# AGENDA

## DEVELOPMENT DETERMINATION PANEL MEETING

**WEDNESDAY 27 OCTOBER 2021**

## APPLICATION FOR MODIFICATION ASSESSMENT REPORT

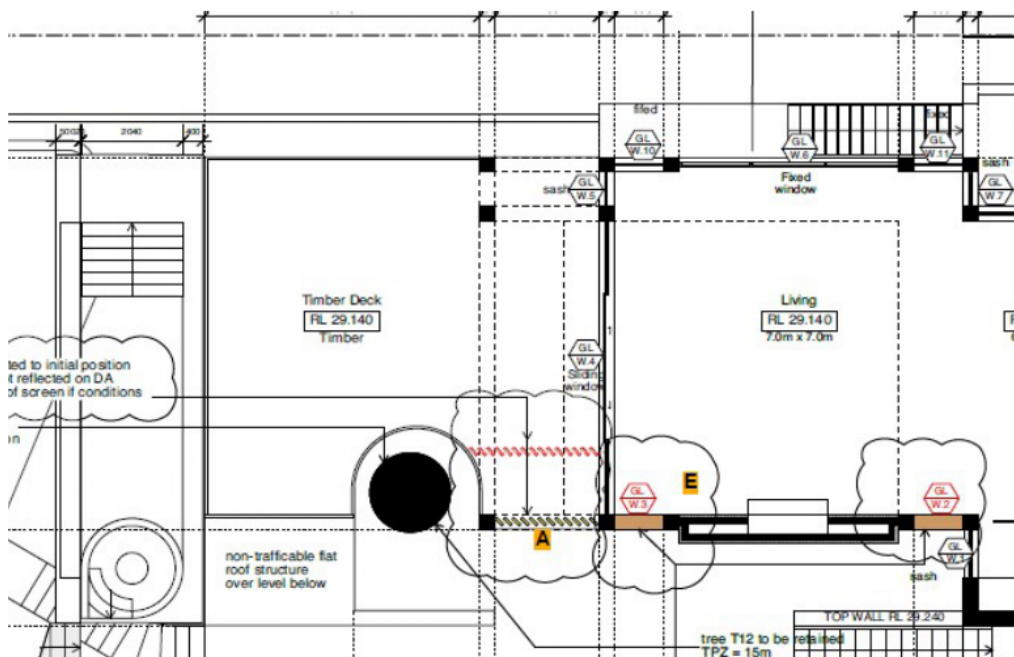
With regards to the privacy screen it would appear that an error in the drafting of point (ii) has occurred whereby the condition relates to the entire width of the southern edge of the ground floor deck, rather than just relating to the western extent of the screen (point i). This is likely due to the fact that one set of plans that was considered (but not approved) under the parent development consent and that the condition was left on the report in error, when it should have been deleted or modified upon receipt of the revised plans.

The condition requires the privacy screen to be relocated 1.5m inward of the deck directly in front of the living room doors, and not at the outer edge of the deck. The circumstance is shown on the below diagram with the approved position shown in red, and proposed position shown in green/yellow:

### B. Modify Condition 26 - Amendments to Approved Plans to read as follows:

### D1.11 Building envelope

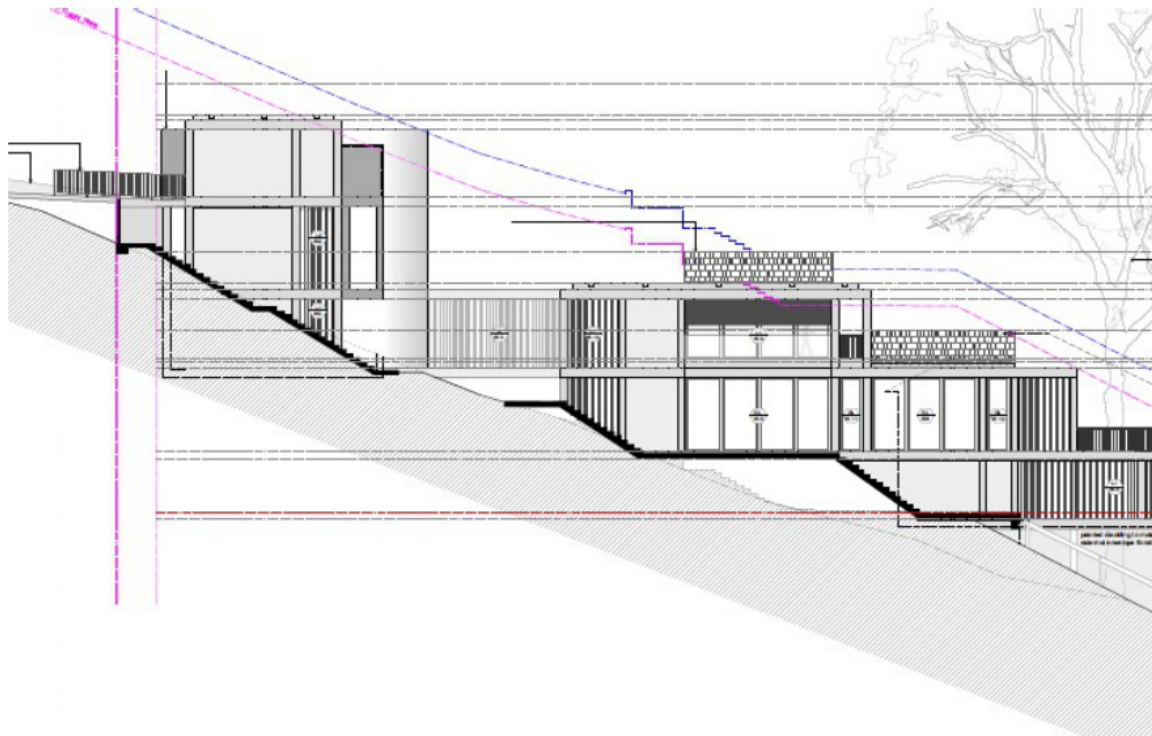
The northern edge of the proposed spa/terrace extension creates a non-compliance when assessed against the building envelope control. The portion of new building which encroaches the prescribed envelope is generally limited to the pool fencing/balustrade and measures 1.9m in height by 3m in width, as depicted in red on the below diagram (drawn by author over architect plans):

*Figure 1. 3D elevation solar access diagram depicting the extent of shadowing by the modification in orange at 12pm on 21 June (Source: Nanna Lesiuk).*

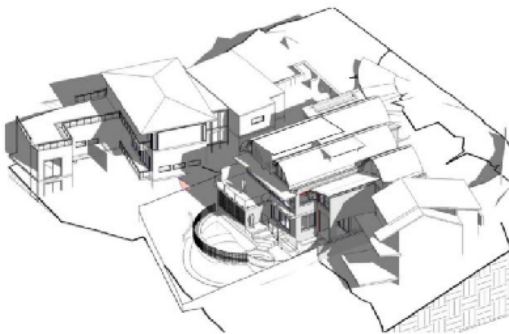
The proposed skillion roof will result in overshadowing towards No. 16 Palm Beach Road, Palm Beach. It is however noted that the solar access diagrams submitted with the application demonstrate that a minimum of 3 hours of sunlight between 9am and 3pm on June 21st will be maintained to the main private open space area and the habitable room windows of No. 16 Palm Beach Road. In particular, areas such as central courtyard, swimming pool and rear garden areas will continue to achieve the minimum solar access as required under this clause.

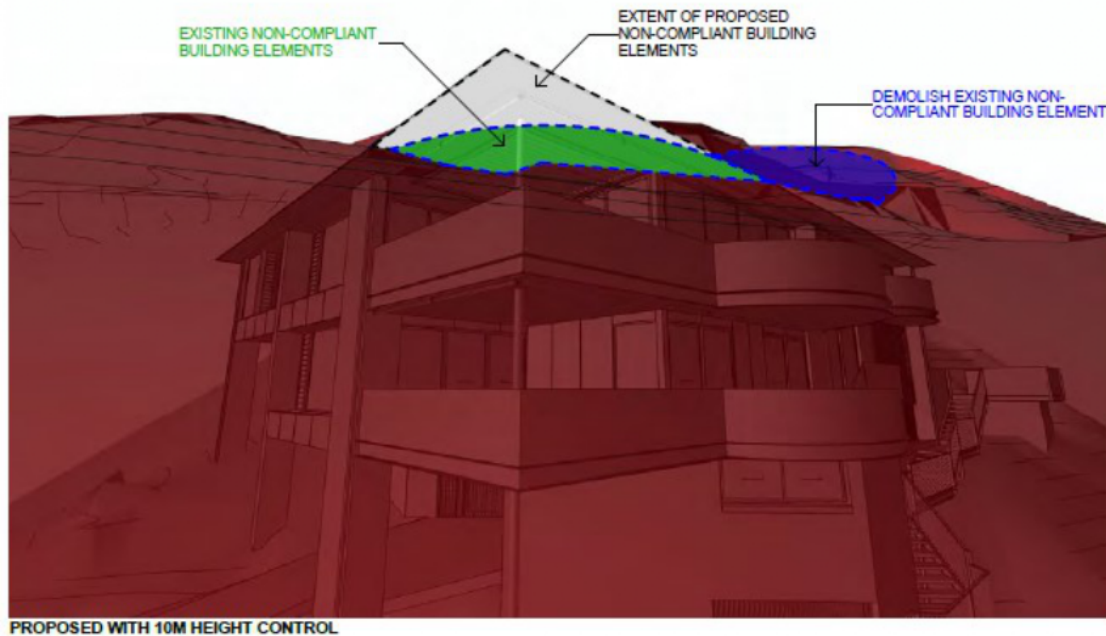
Development standard:	Height of buildings
Requirement:	8.5m
Proposed:	11.37m
Percentage variation to requirement:	33.8%

Figure 1: Representation of envelope non-compliance at north-west elevation

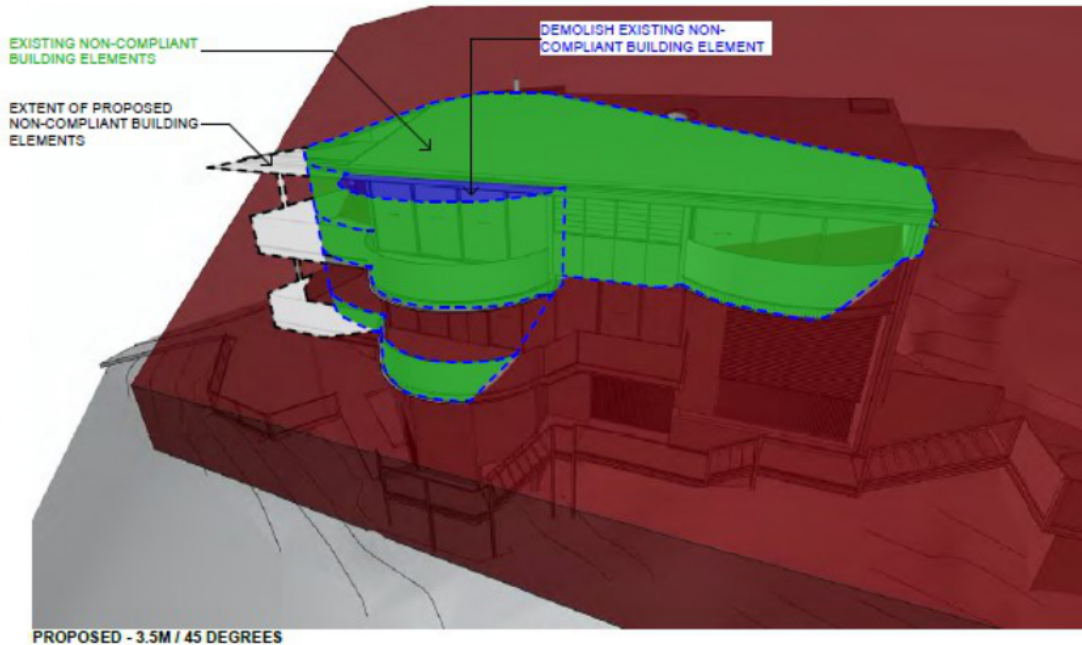
The proposal does not comply with the control for building envelope at the north-western elevation. This can be seen in a representation of the non-compliance **provided by** the applicant below:

Figure 1: Excerpt from Watershed Drawing DA23 Issue I (Height Controls)

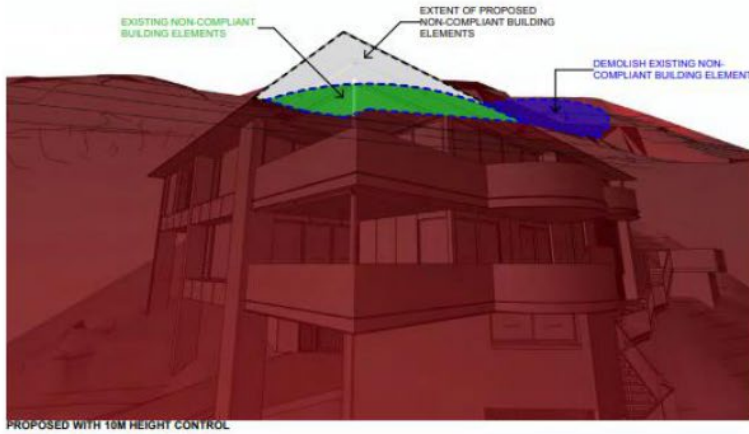
The maximum height of the proposed upper awning is in effect a minor extension of the existing awning height at first floor level (roof ridge over existing deck) due to the change in shape from round to square at a steeper portion of the site. The modification of the existing form will provide the most architecturally pleasing result. Although the development will not

**Figure 1.** The additional building height of the privacy screens shown in green.

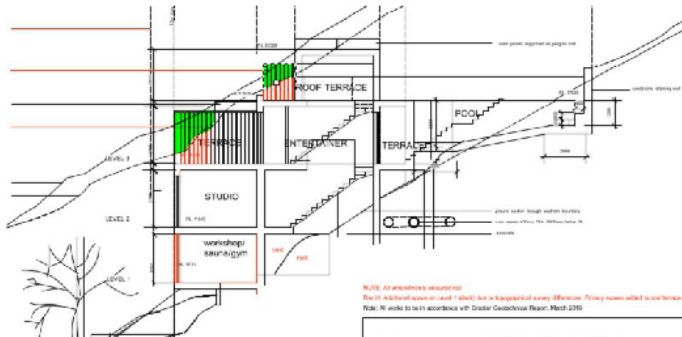
The proposed height of the additional privacy screens screening the Studio Level 3 and roof terrace contribute to further non-compliance with the 'Height of Building' control of 8.5m, at 10.2m - 10.5m (variation of up to 23%). The non-compliance in height is a direct result of the significant slope of the subject site. See Figure 1 below.

The additional building height is below the maximum buildings height of 14.6m approved via DA10.2016.126.1, and are predominantly beneath the approved maximum RL of the studio (RL203.29) as evident on the architectural plans. Overall, the proposal achieves a building height that is consistent with other residential dwelling on the downward slope of Seaforth Avenue. The proposed development integrates articulation via stepped wall planes, fenestration and changes in materials to reduce apparent building mass.
